SERVICE BULLETIN

No. 108

Date February 4, 1960

Subject: Re-Routing of Oil Breather Line, Concerning All Ercoupes, Aircoupes and Fornaires Up To Serial #5715

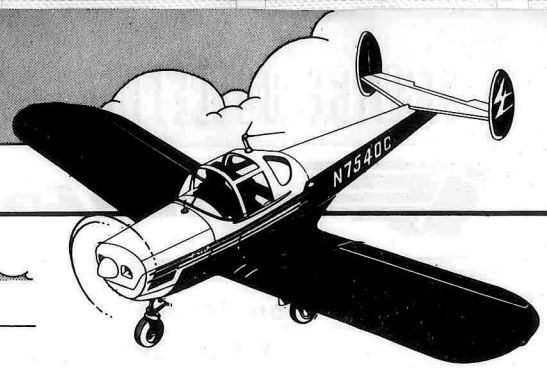
Reason for Modification:

The present oil breather tube empties into the forward region of the engine compartment and drains down the belly cowl. The spread of oil in the belly cowl creates a dirt trap which makes an excessively dirty engine compartment.

The sketch below shows the new routing of the oil breather tube.

The re-routing of the oil breather line, as proposed by this service bulletin, will empty oil vapors almost directly to the outside of the airplane at the most rearward region of the belly cowl. This modification is advantageous in that it will help to eliminate an excessively dirty engine compartment. Another feature is that the breather line is routed higher than the engine outlet which will tend to condense oil vapors in the breather tube and return the oil to the engine rather than expelling it to the outside. This reduces oil consumption.

Forney Modification Kit (F.M.K.) #28 is available which contains the necessary tubing, mounting brackets, hardware, and complete instructions with service installation drawing #F 48205.
